To: Plan Holders for SLN Terminal Expansion  
Salina Regional Airport  
Salina, KS  
AIP Project Number 2-20-0072-054/055-2024

Transmitted herewith Addendum No.2 to the Issued for Bid Contract Documents, Specifications and Plans dated July 2, 2024 for improvements to the Salina Regional Airport.

**ADDENDUM NO. 3**  
**TO**  
**CONTRACT DOCUMENTS, TECHNICAL SPECIFICATIONS, AND**  
**PLANS**  
**FOR IMPROVEMENTS TO THE**  
**SALINA REGIONAL AIRPORT**  
**SALINA, KS**  
**AIP PROJECT NUMBER 2-20-0072-054/055-2024**

**A4** ENTRY CANOPY NORTH ELEVATION  
 3/8" = 1'-0"

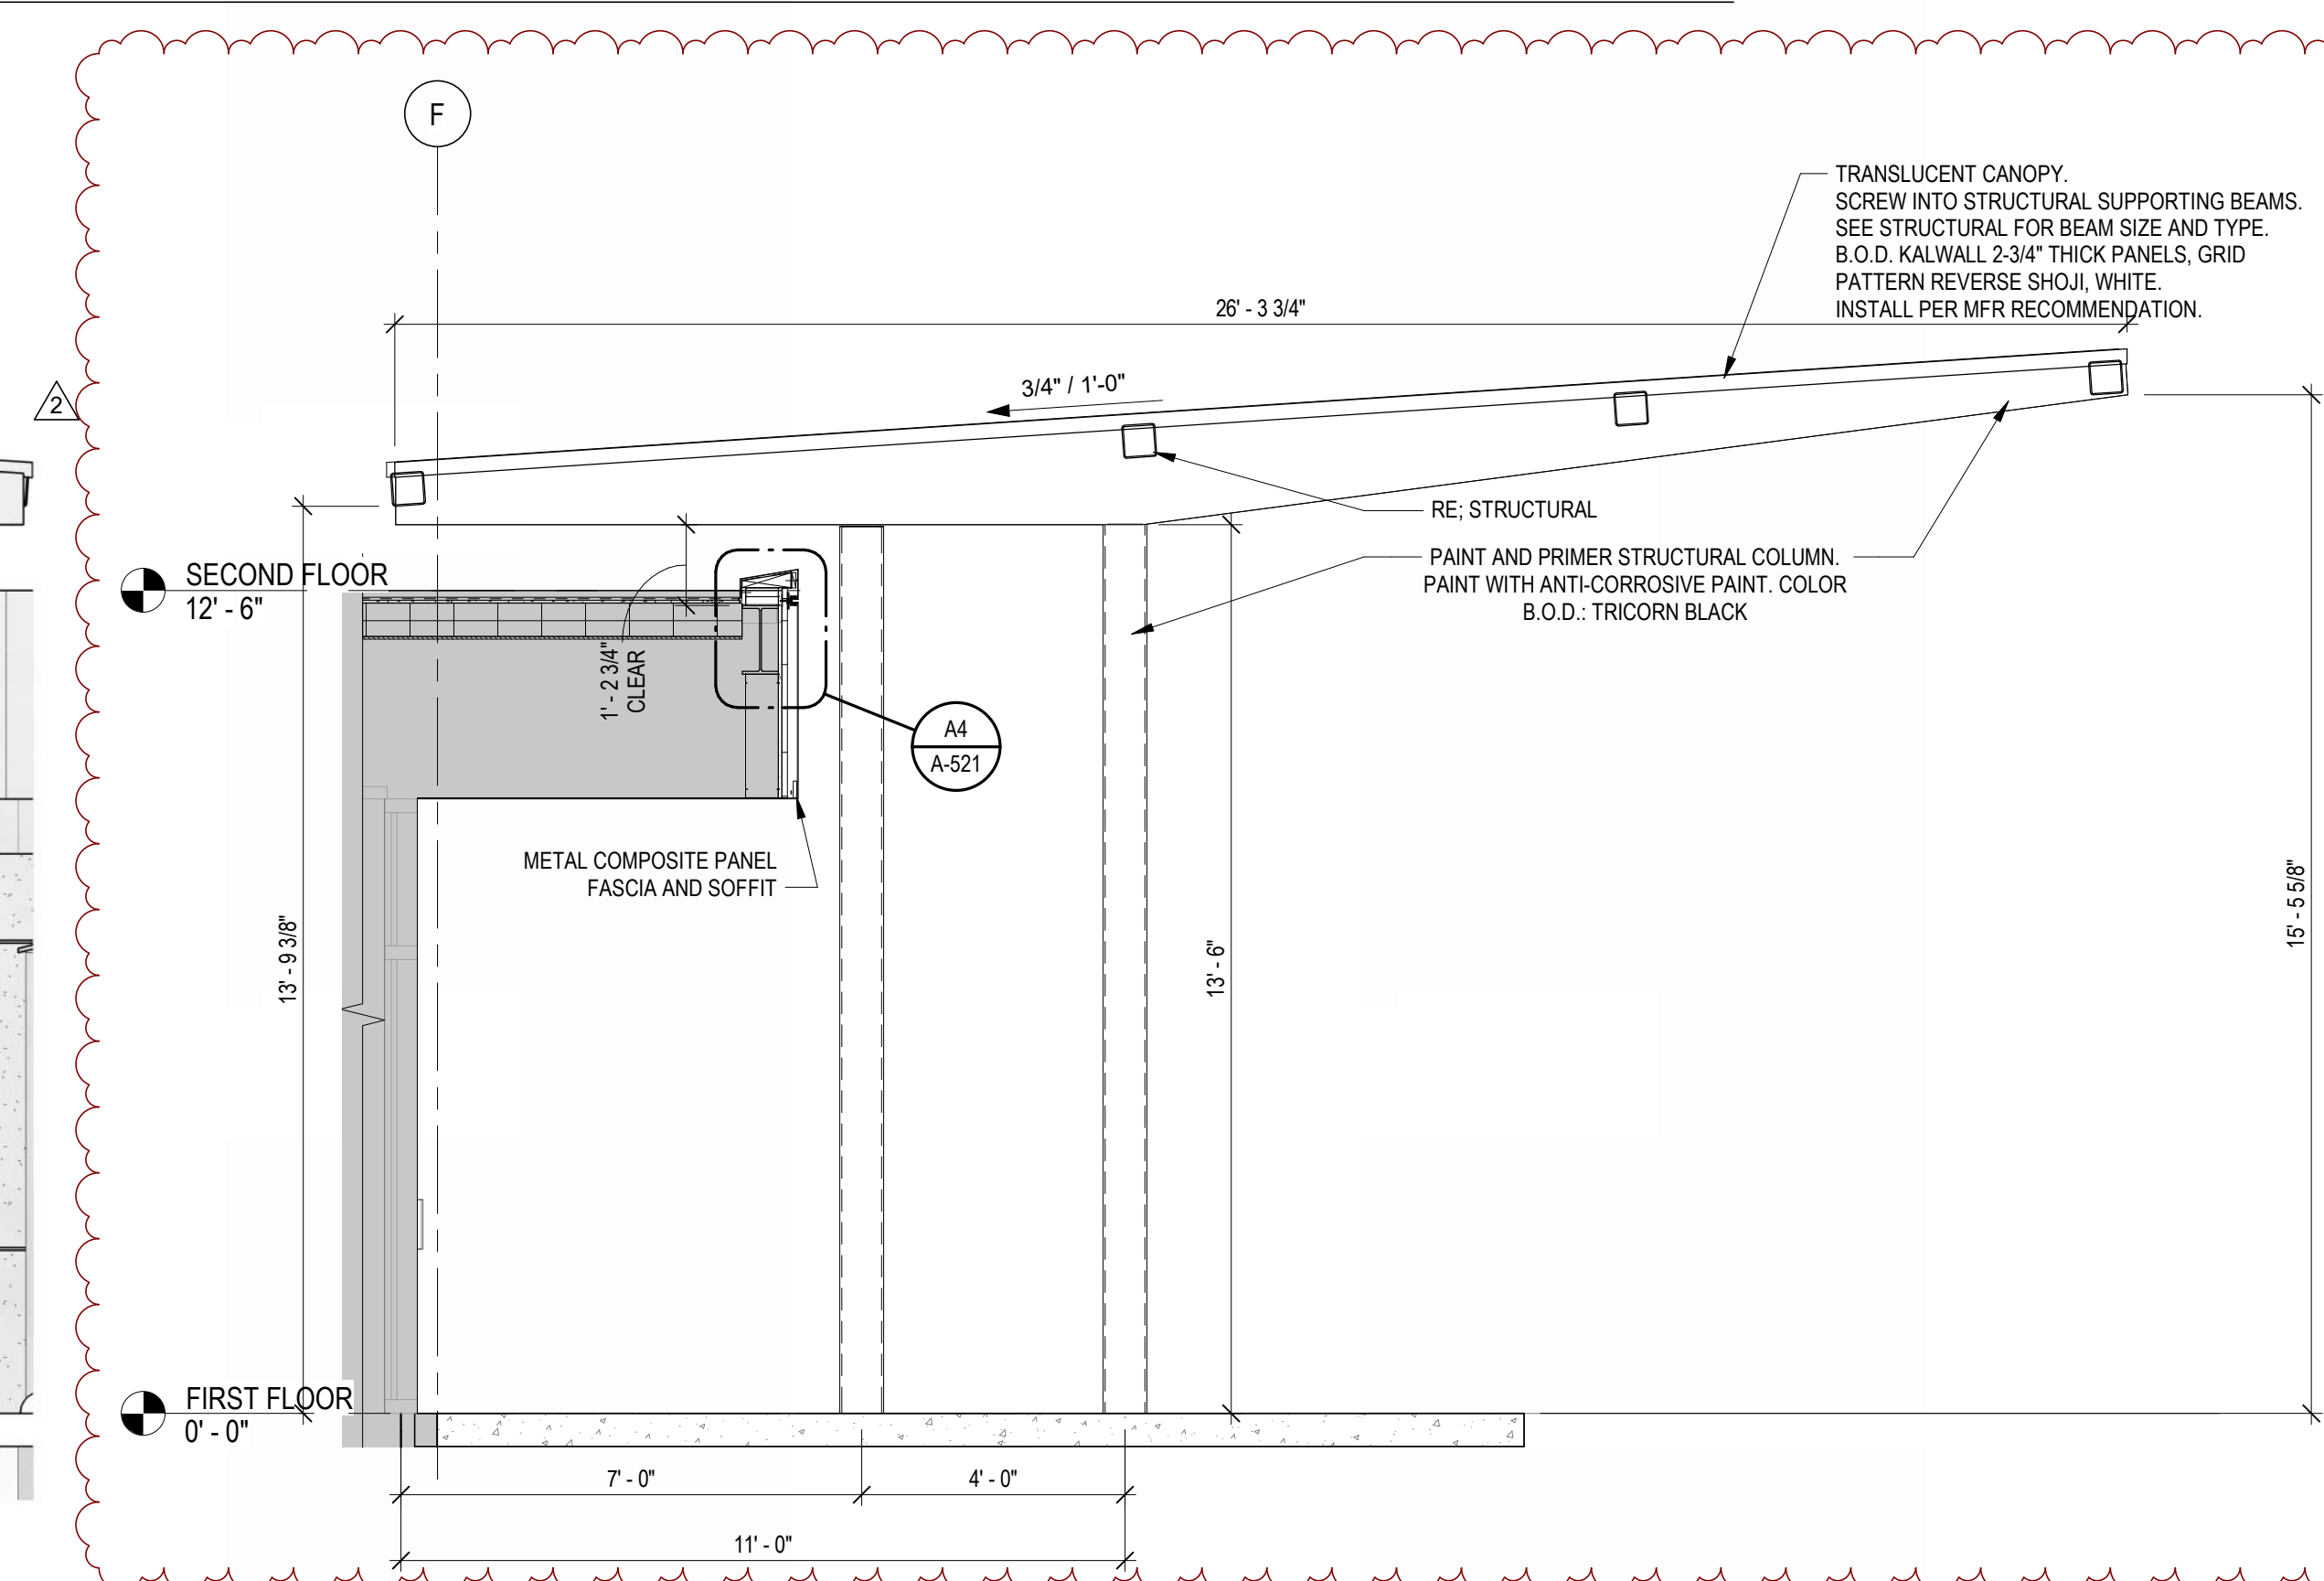
**A404 ENLARGED ENTRY CANOPY PLANS AND DETAILS**

**Justification:** For clarification of Entry Canopy roof panel and dimensional information.

SHEET NAME:  
DEMOLITION FLOOR PLANS RCP

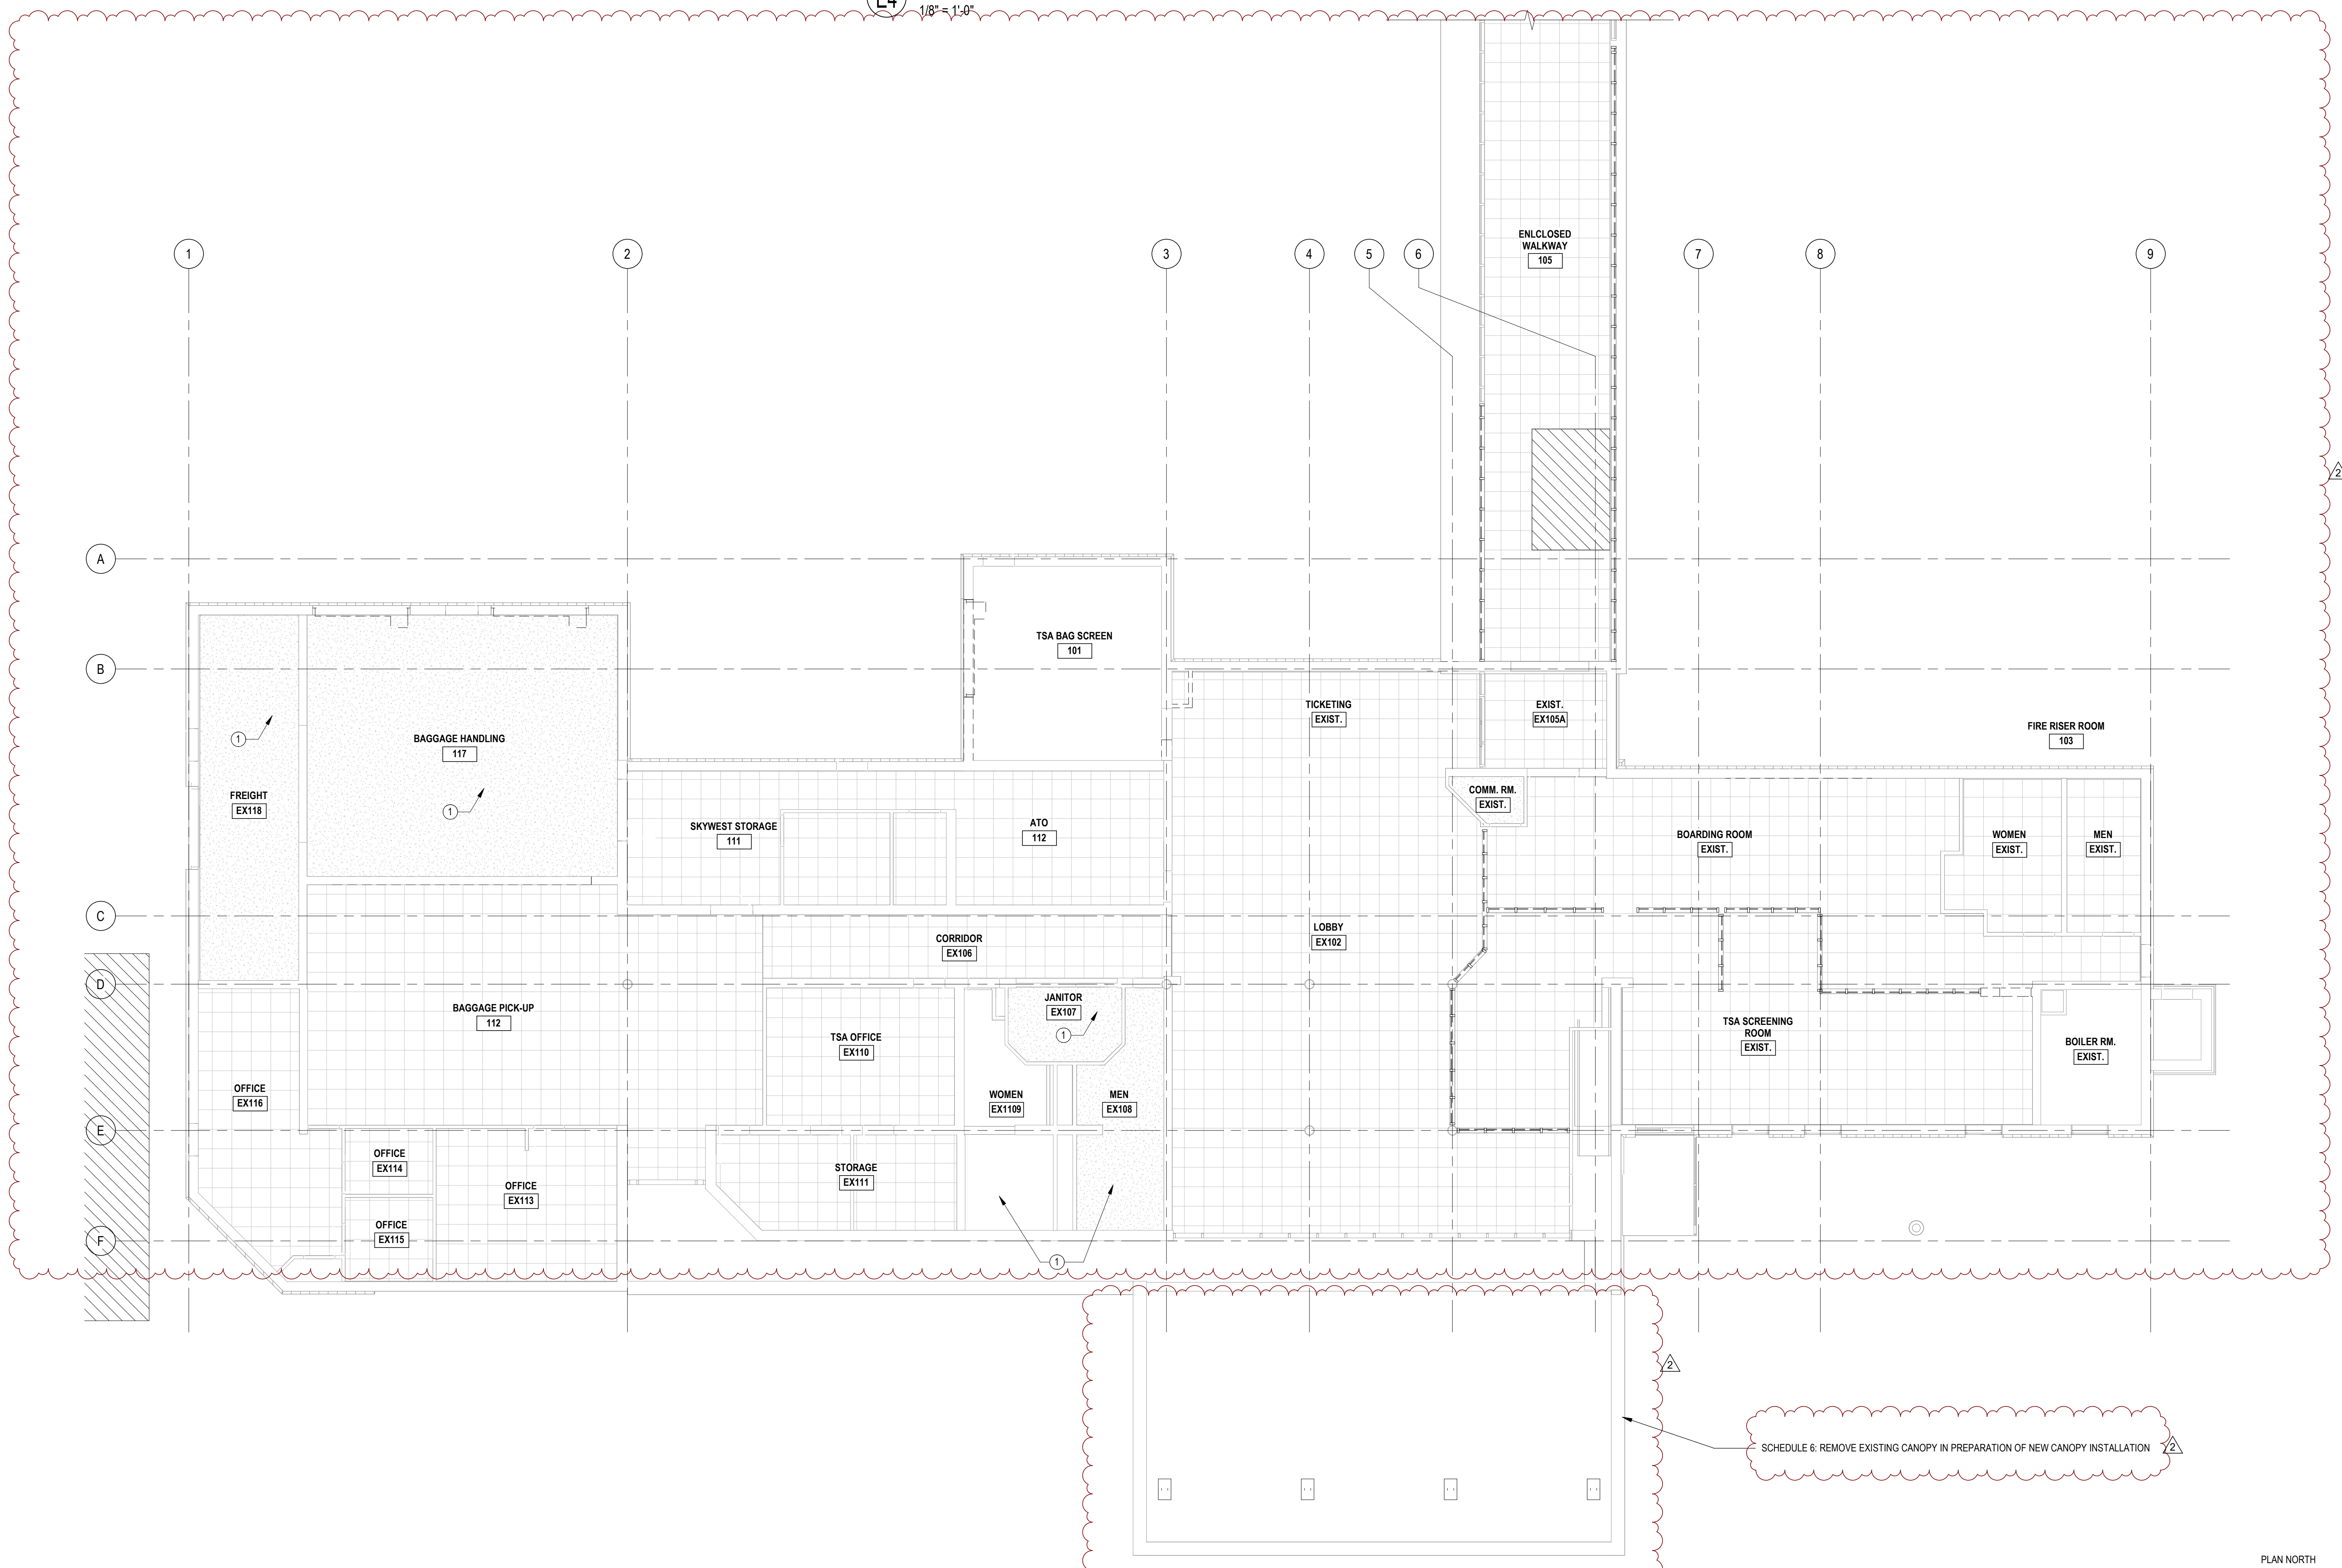
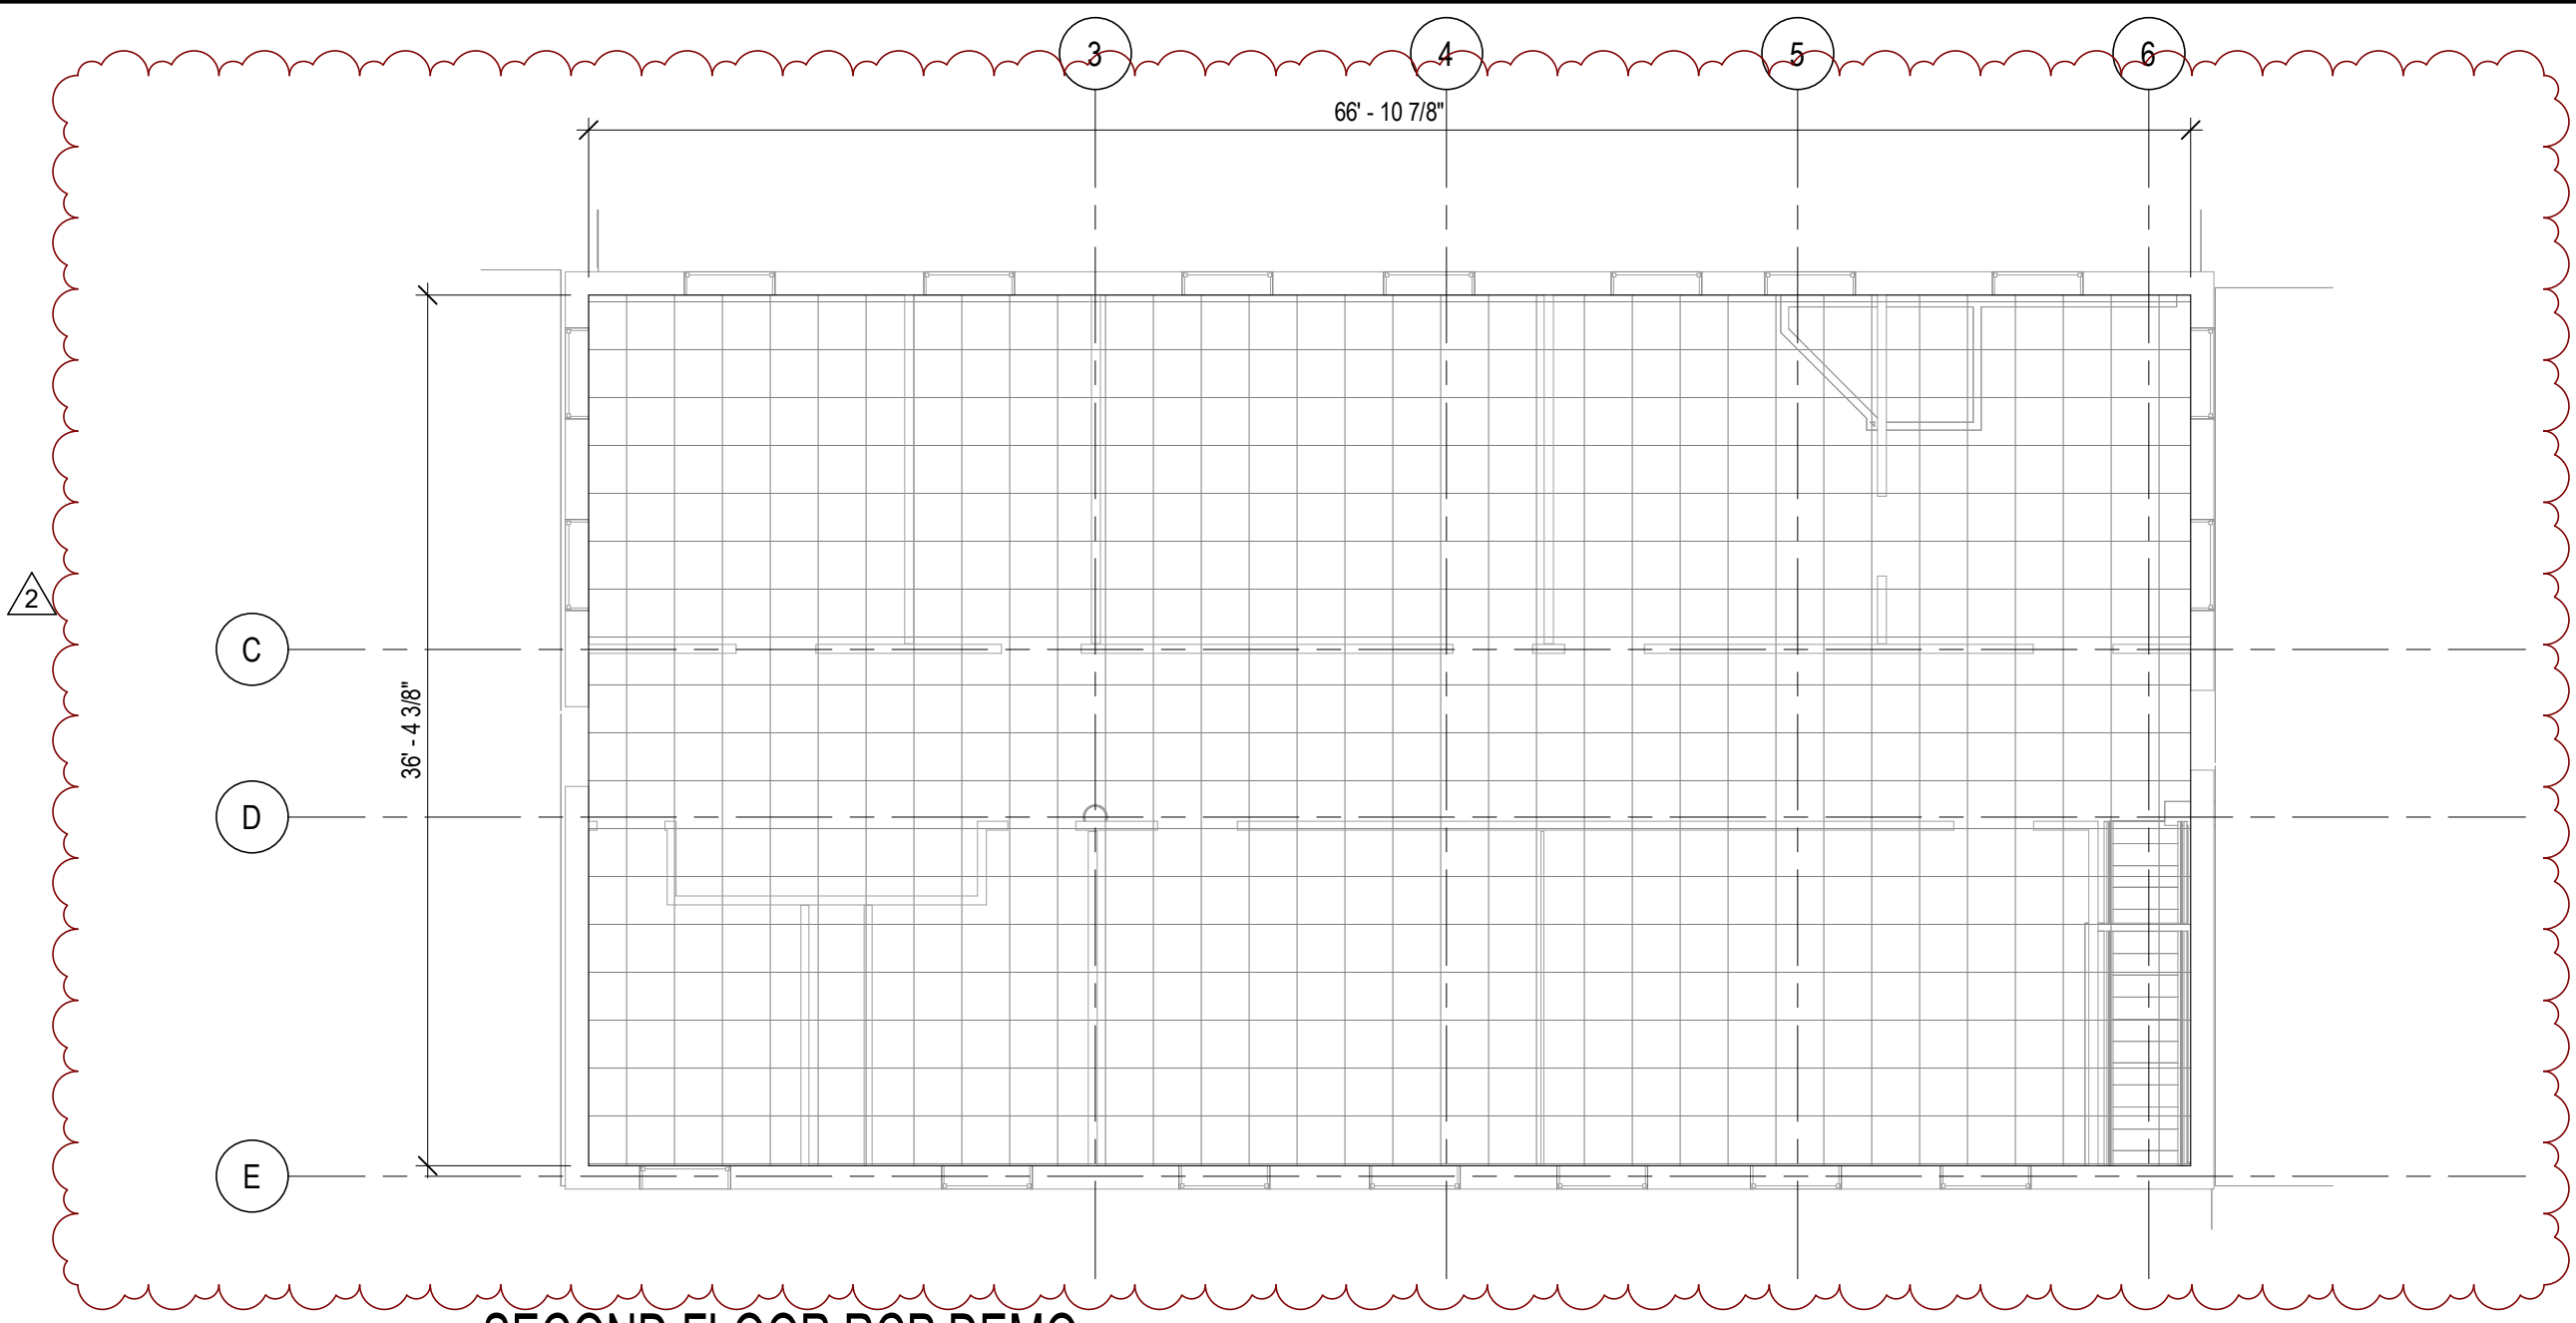
**AD102 DEMOLITION FLOOR PLANS RCP**

**Justification:** For clarification:

7. *Can Ceiling tile and grid remain for sprinkler installation?*  
**RESPONSE:** Ceiling tile and grid throughout the entire airport will NOT be required to be replaced. Contractor will be required to replace all damaged grid and ceiling tile, including soiled tile. All cut or bent ceiling grid sections must be replaced. All ceiling grid when work is complete must meet Specification quality requirements.

CEILING TILE AND CEILING GRID TO REMAIN. CONTRACTOR TO USE CARE TO REMOVE SECTIONS OF THE CEILING FOR THE INSTALLATION OF THE SPRINKLER SYSTEM. CONTRACTOR RESPONSIBLE FOR REPLACEMENT OF ALL BROKEN AND/OR SOILED TILE. ALL CUT OR BENT GRID IS TO BE REPLACED. COMPLETED CEILING AFTER SPRINKLER INSTALLATION MUST MEET ALL SPECIFICATION QUALITY REQUIREMENTS. ALL GRID SECTIONS MUST BE PROPERLY ALIGNED AS A NEW INSTALLATION. CONTRACTOR TO PATCH ALL DRYWALL CEILINGS TO MATCH EXISTING FINISH AND REPAINT ENTIRE CEILING AREA.”
